ASSESSMENT REPORT

Section 96(2) Modification Oakdale South Industrial Estate (SSD 6917 MOD 1) Concept Proposal and Stage 1 DA Layout

Figure 6: Proposed Modified Concept Proposal Layout

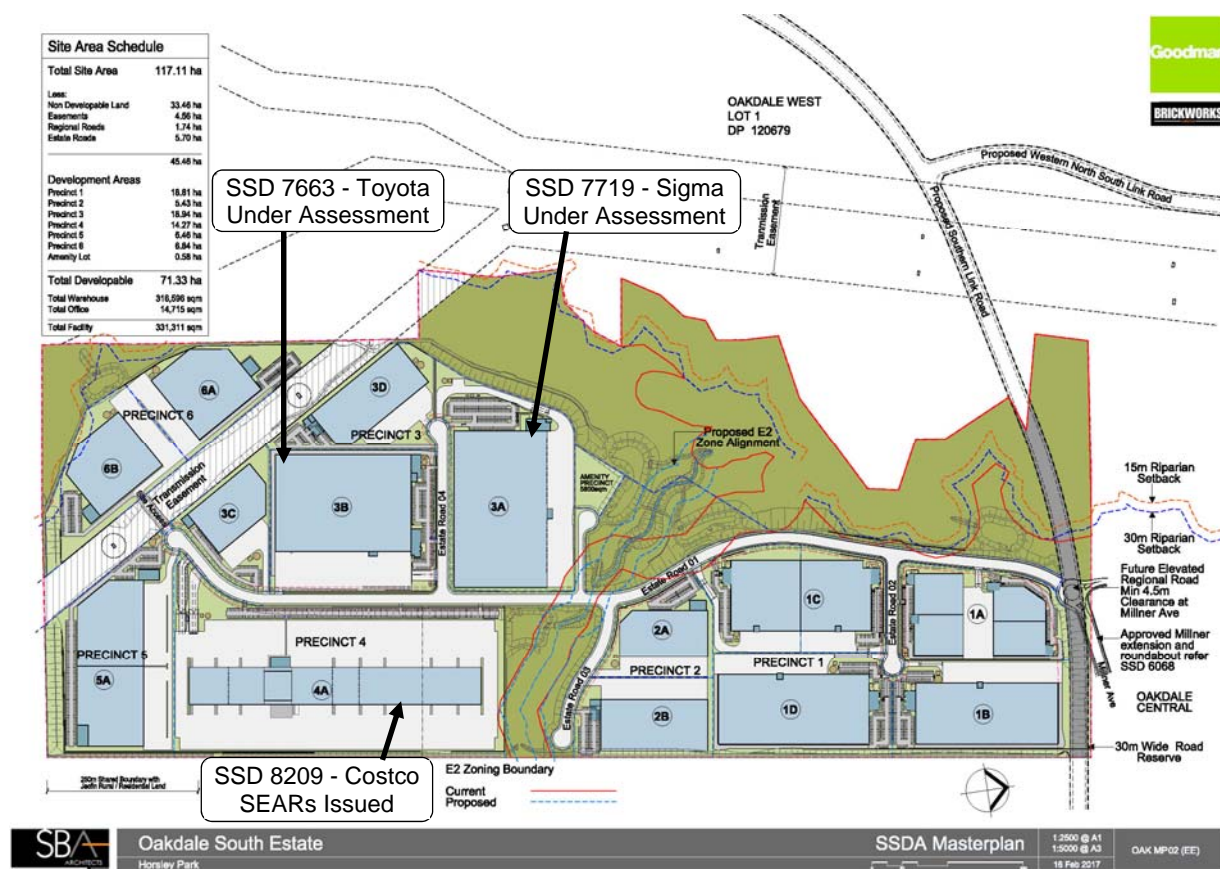
Precinct 4 would replace three separate smaller envelopes with one elongated envelope parallel to the eastern boundary. The envelope in precinct 5 would be scaled down, but would be moved closer to the 30 m deep, 5 m high earth bund setback along the southern boundary (see **Figure 6**).

Figure 9: Southern (Bottom) and Eastern (top) Noise Walls and Setback Sections

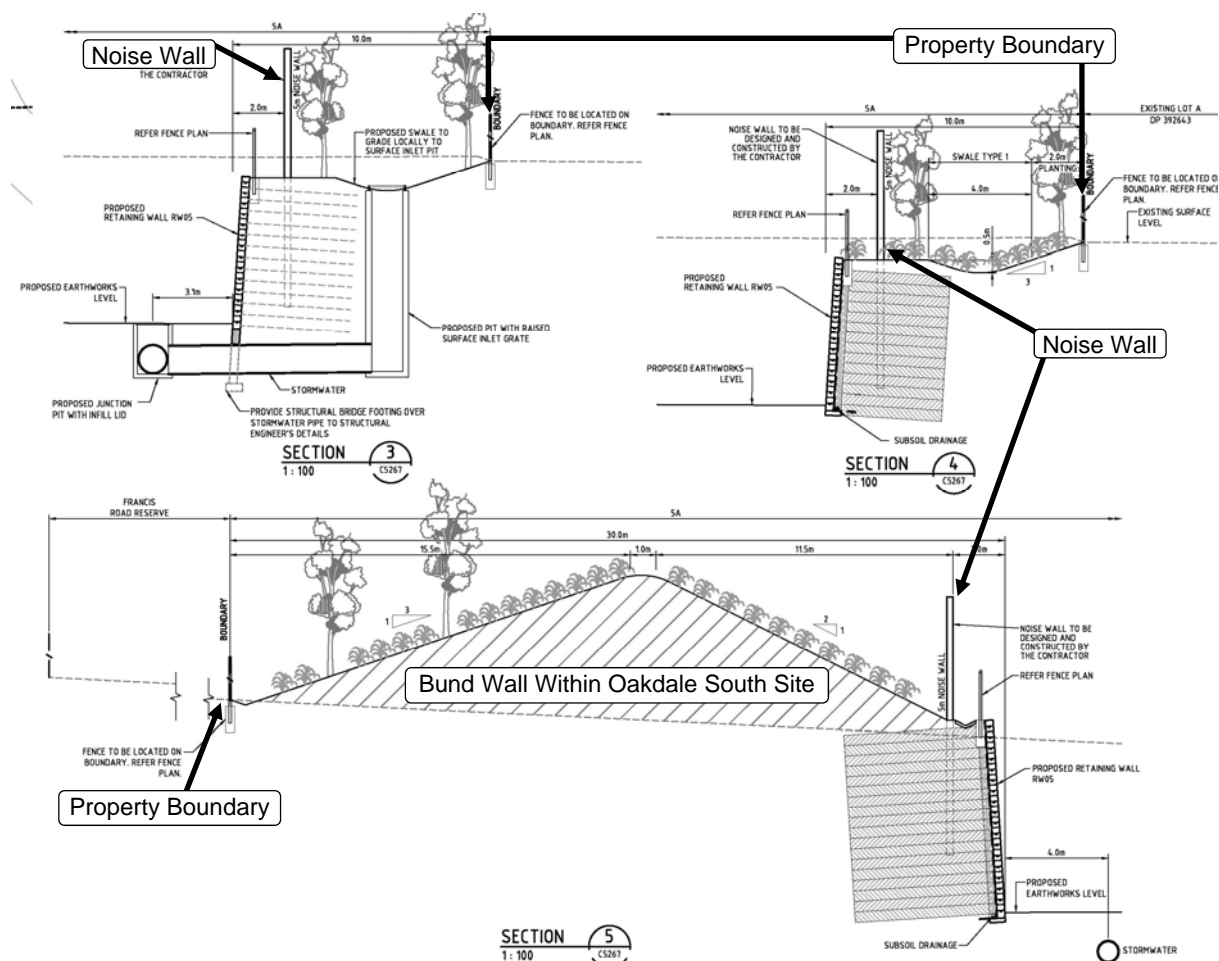
To mitigate potential changes in the cumulative noise impacts of the development, the amended Concept Proposal and Stage 1 DA includes two extended 5 m high noise walls along the southern and eastern boundaries (see **Figure 9**).

- extending the noise wall above what is proposed under the modification application would have a negligible effect on mitigating the cumulative operational noise emissions of the development; and

- the Applicant not be permitted to use the 2 dB(A) increase provided in the approved noise limit (i.e. a noise limit of 38 dB(A);
- the cumulative noise emissions from the Oakdale South and Jacfin lands meet an Amenity Noise Level Leq(period) of 40 dB(A); and
- the descriptions of the noise receiver locations and noise limits for the adjacent RU4 zoned land be revised to list the Jacfin land as a fourth receiver point under the development consent.

However, the Department agrees there is scope to revise the existing descriptions of receptors in the development consent and clarify the application of the estate wide noise limits between Condition B18 of the Concept Proposal and Condition E35 of the Stage 1 DA. This is because the current wording of Conditions B18 and E35 list the same noise limits. This would potentially allow the Applicant to operate the Stage 1 DA using the full noise 'envelope' under the Concept Proposal and potentially result in the limits being exceeded at nearby sensitive receivers when all potential noise sources in the Concept Proposal become operational. Therefore, the Department has recommended conditions to:

- amend Condition E35 to remove the noise limits table from the Stage 1 DA component of the development consent and require the Applicant to operate the Stage 1 DA to ensure compliance with the noise limits of the Concept Proposal under Condition B18;
- amend the descriptions of the three receiver locations to clarify the areas they relate to; and
- amend Condition E36 to require the Applicant to construct the expanded noise walls as detailed in the modification application.

Figure 16: Revised Vegetation Management Zones under VMP

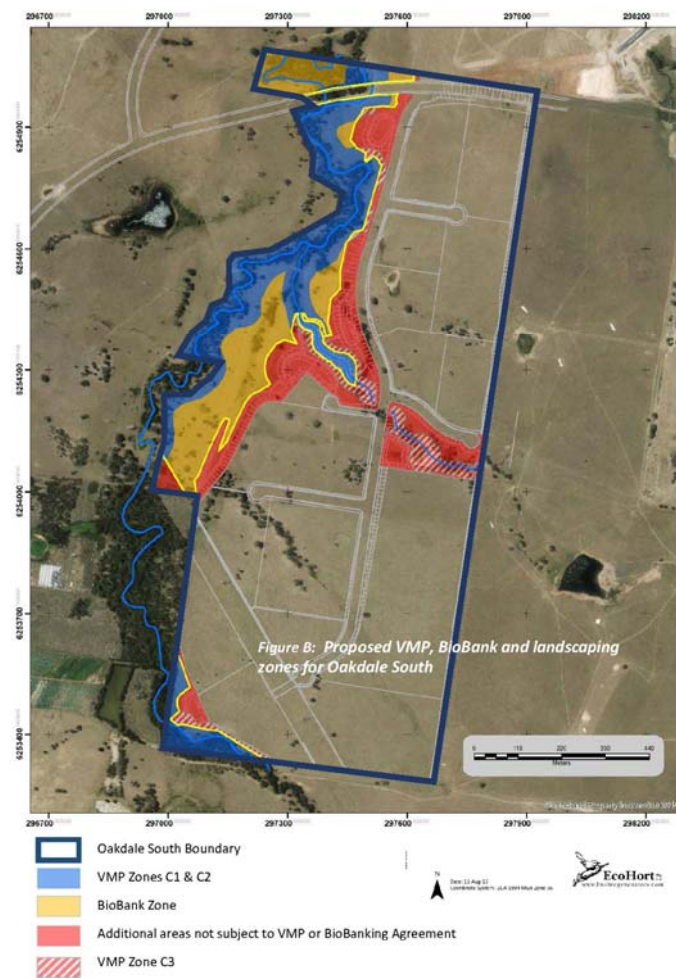
To clarify this arrangement, the revised VMP details the overall vegetation management zones (see **Figure 16**) and specific management zones along the riparian corridor where the Applicant intends to implement management measures consistent with the *Water Management Act 2000* (see **Figure 17**).

The Department has reviewed the revised VMP and is satisfied it clarifies the management measures that would be implemented in the riparian corridor and creek realignment area, subject to including reference to the updated documents in the recommended notice of modification.

Figure 18: Overview of Amended Ropes Creek Realignment Works

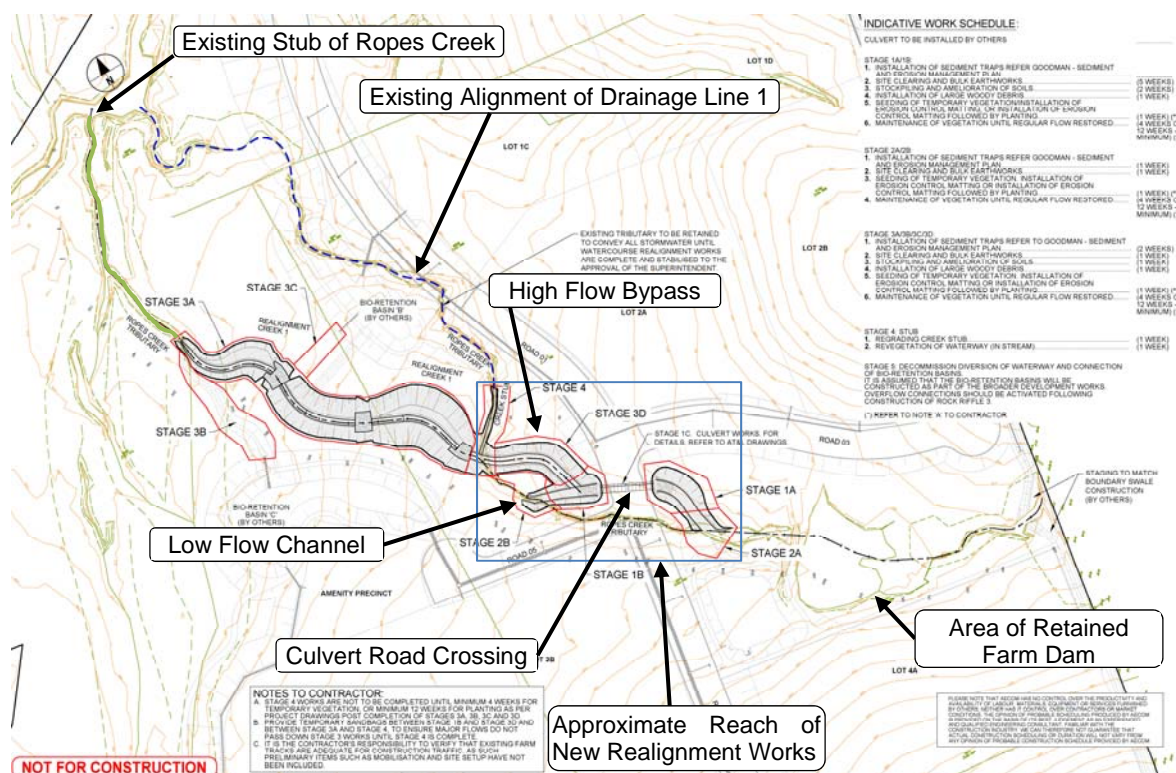
- increase the overall length of realignment works from approximately 250 m to 410 m;
- retain the existing farm dam as a habitat feature;
- retain a small extent (50 m) of creek as a low flow channel;
- include a high flow bypass channel to divert stormwater from the retained extents of Ropes Creek during flood events;
- incorporate instream benches, pools and riffles to improve hydraulic conditions; and
- provide a shorter single road crossing with two box culvert structures (one for drainage and one for fauna passage) (see **Figure 18**).

DPI raised no objection to the revised realignment design and requested conditions requiring the design to: ensure consistency with their guidelines for *Controlled Activity on Waterfront Lands*, facilitate fauna passage, restore the area to a stable, naturalised system; and ensure the banks are fully vegetated with native plant and tree species. The Department notes the updated AECOM watercourse design and updated civil plans by AT&L respond to and incorporate DPI's comments. The revised VMP and riparian management zones have been designed to integrate with the updated design for specific plant species and management measures within the riparian zones.

The Department considers the addition of further riparian features including pools, benches, riffles and a low/high bypass channel will provide improved hydraulic performance of the realigned creek and provide for improved revegetation plantings while facilitating the amended Concept Proposal and Stage 1 DA layout. The Department considers the existing conditions of consent provide satisfactory controls for the riparian area, subject to administrative changes to reference the updated design plans and VMP and require their implementation in the recommended notice of modification.

Figure 20: View Locations from Approved (Red Outlines) and Proposed Concept Proposal Layout

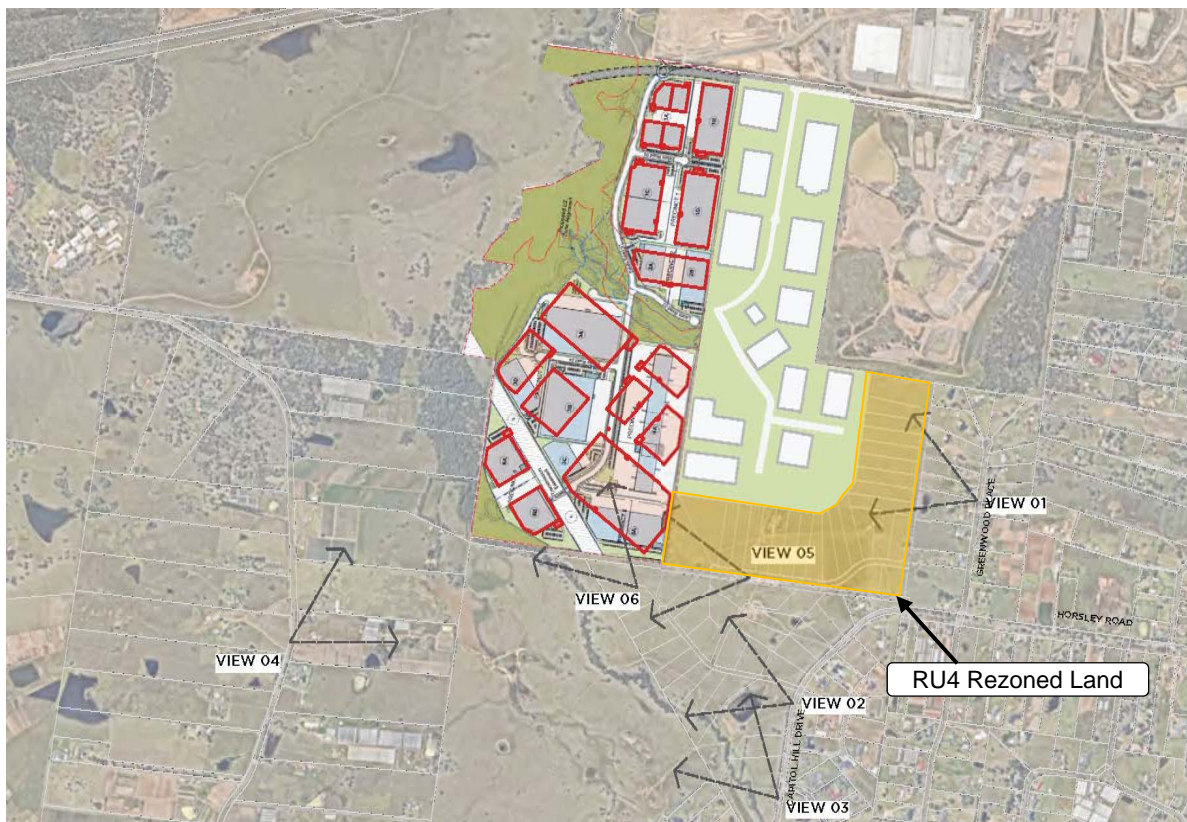
The Applicant has submitted an updated Visual Impact Assessment (VIA) of the proposed Concept Proposal layout to assess the future visual impacts from a range of vantage points surrounding the site (see **Figure 20**). The Department considers views potentially most affected are those from the south at the vacant Capitol Hill Subdivision and from existing dwellings along Greenway Place to the east.

- views from Greenway Place (view 01 in **Figure 20**) would be screened by future development and the extended noise walls. The 10 m landscape buffer required under the Concept Proposal and Stage 1 DA would screen the noise walls;

- views from locations 02 and 03 (see **Figure 20**) would be obscured by an existing ridgeline running east to west in the Capitol Hill subdivision and are generally consistent with the visual impacts of the development as originally approved; and

- views to the north from the Capitol Hill subdivision (view 06 in **Figure 20**) would be impacted by the development, however these impacts would be consistent with those originally assessed. The amended layout would be partially screened by the 30 m landscape setback containing the 5 m high vegetated earth bund wall (see **Figure 21**) and further mitigated by earthwork levels in the south west corner of the site (up to 6 m of cut). The Department notes the presence of the TransGrid easement prevents the bund wall from covering the entire southern site boundary (see **Figure 22 to 25**).

Accordingly, the Department considers the amended Concept Proposal and Stage 1 DA would not be considered a dominant feature in views of the broader visual landscape from vantage points surrounding the site. The Department is satisfied the visual impact of the modified Concept Proposal and Stage 1 DA is acceptable and similar to the development as originally approved.
